U.S. NUCLEAR REGULATORY COMMISSION

Report No. 030-19025/86001(DRSS)

Special Inspection Summary

Inspection on March 19 through April 14, 1986 (Report No. 030-19025/86001(DRSS))

← MAZE  
DETECTOR,  
SHOT REMOVED.

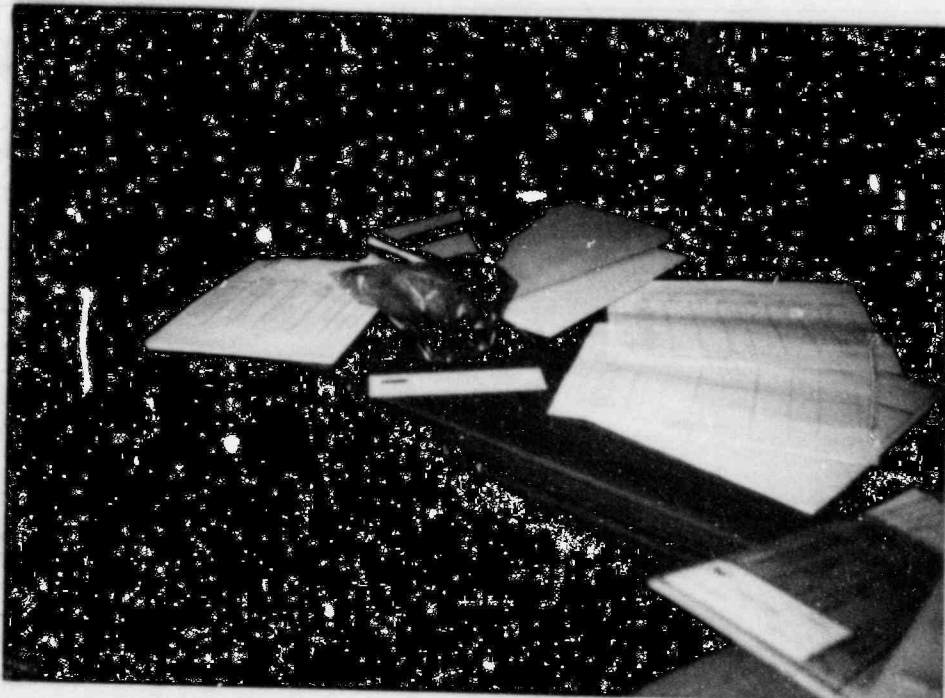
A facilities tour on March 19, 1986 showed that lead shot was placed around both the cell and maze GM detectors (see Attachments 1 and 2). According to Pete Robles, the shot was placed on the detectors several months earlier when "empties" (low density material or no product) were being irradiated. The "empties" caused false alarm shutdown of the irradiator due to the high (scatter) radiation levels detected by the GM probes. The lead shot decreased the detector sensitivity to permit operation of the irradiator but not enough to compromise safety, in that the probes would still have been able to detect a Co-60 pencil accidentally brought out. This explanation was corroborated in a letter from Thomas Mates to NRC dated April 3, 1986 (Attachment 4).

← THIS BAG  
CONTAINED ~3.4  
POUNDS OF LEAD  
SHOT, WRAPPED  
AROUND MAZE  
DETECTOR AND  
SECURED WITH  
DUCT TAPE -  
IT WAS REMOVED  
DURING 3/19/86  
INSPECTION

← CELL DETECTOR  
BOX

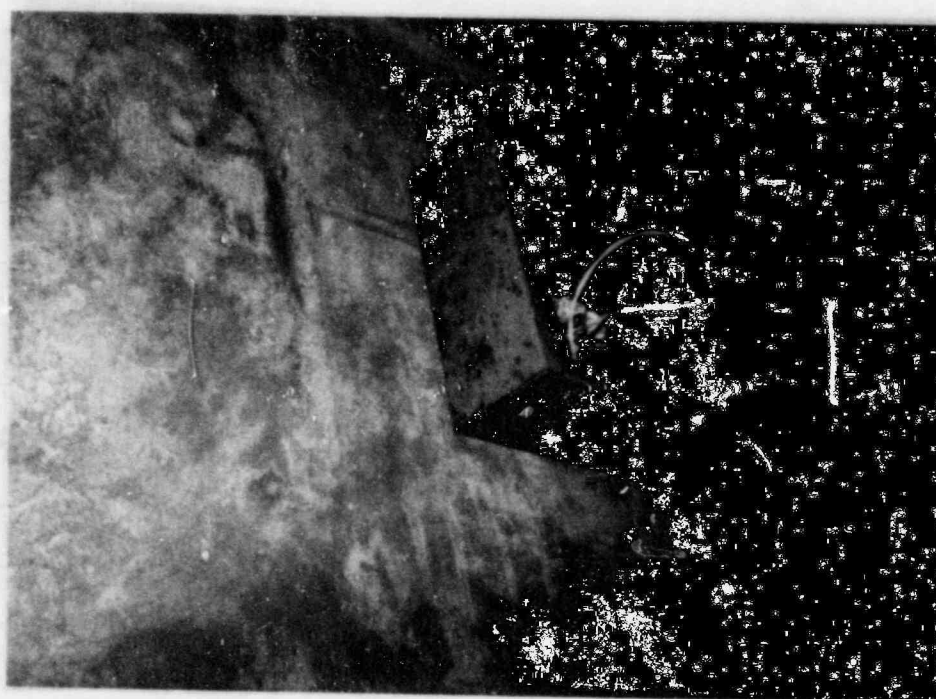
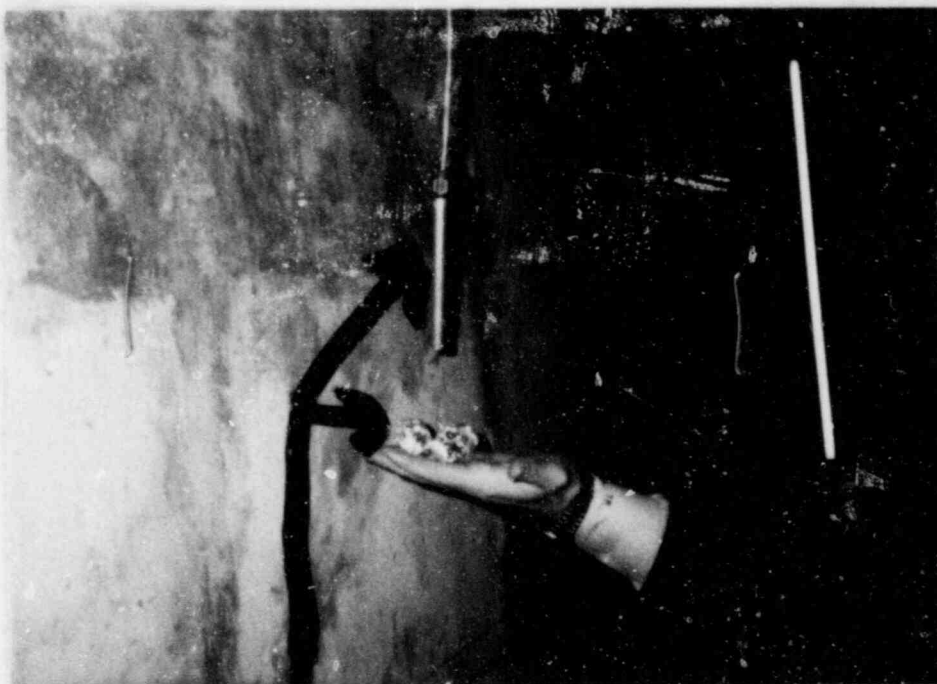
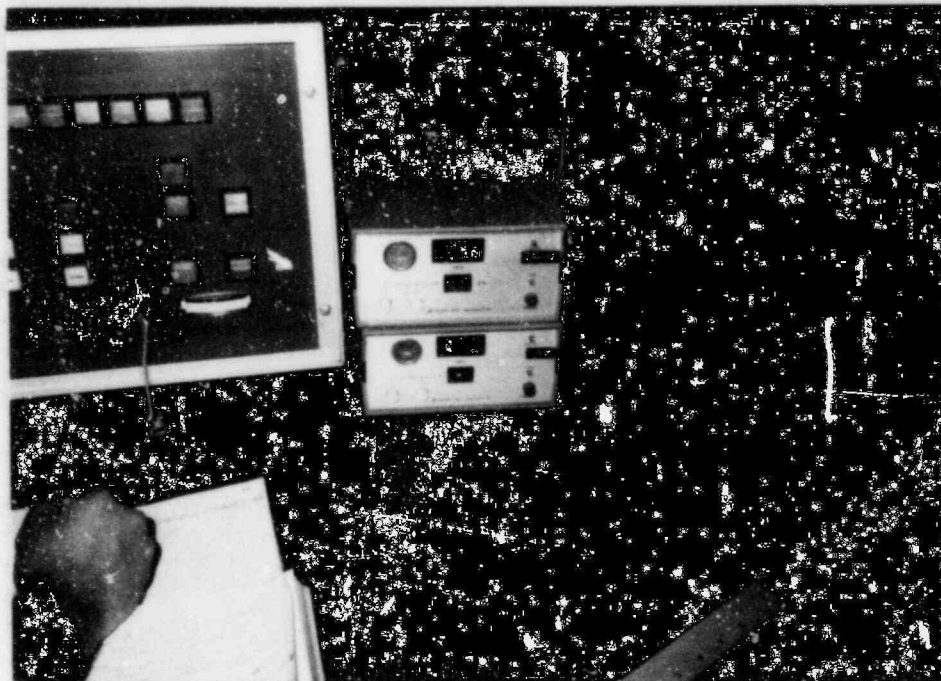
← CELL DETECTOR  
G.M. PROBE LAYS  
ON BOTTOM OF BOX,  
SURROUNDED BY  
FOIL WRAPPED  
PACKETS OF  
LEAD SHOT

↑ TOM MATES, RSI GENERAL MANAGER,  
HOLDING FOIL WRAPPED LEAD SHOT; CELL  
DETECTOR G.M. PROBE IS HANGING ABOVE.

← CELL AND  
MAZE MONITORS,  
SOURCES DOWN  
(SHIELDED);  
NOTE READOUTS

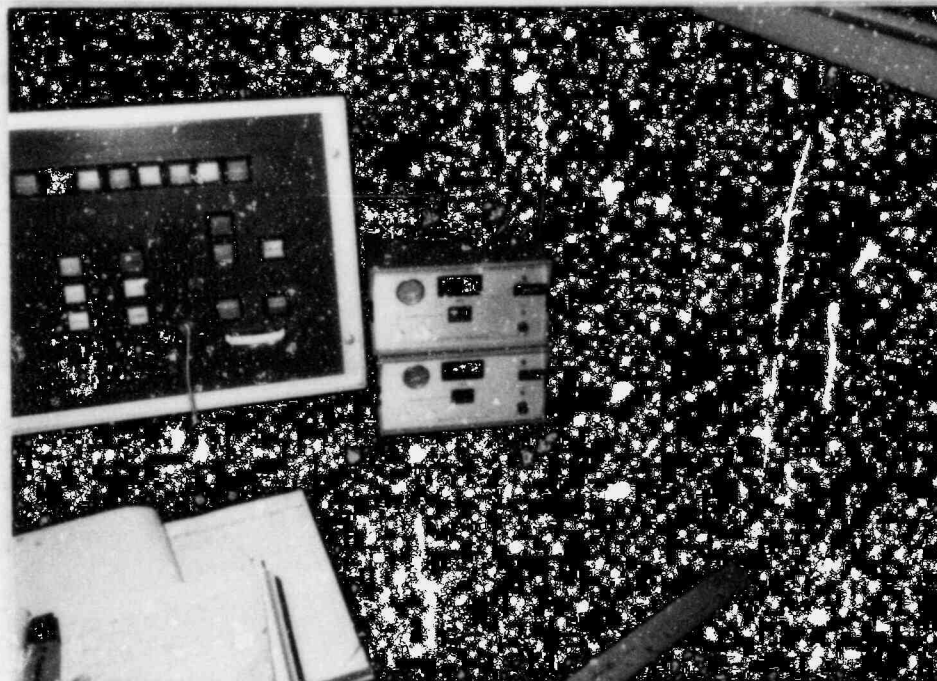
A facilities tour and operations checks on March 19 and 20, 1986 showed that the cell monitor only read out when the sources were in the shielded position (down in the pool) as per design. This is not a malfunction because the cell monitor is used to detect any source in the "up,"

unshielded, position when the other control panel instruments indicate the sources are "down" and shielded (see Attachment 3). When the sources are "down" and shielded, the cell monitor readout is normally a background level of radiation. The maze monitor readout is also background when the sources are "down" but changes to numbers showing elevated radiation levels when the sources come "up." Both monitors were functioning on the dates of the site inspection, March 19 and 20, 1986. These monitors are Xetex 501 1R models with A-1 or A-2 probes and were last calibrated August 21, 1984.

← CELL AND  
MAZE MONITORS,  
SOURCES UP,  
EXPOSED...  
NOTE CELL  
MONITOR DISPLAY  
IS BLANK
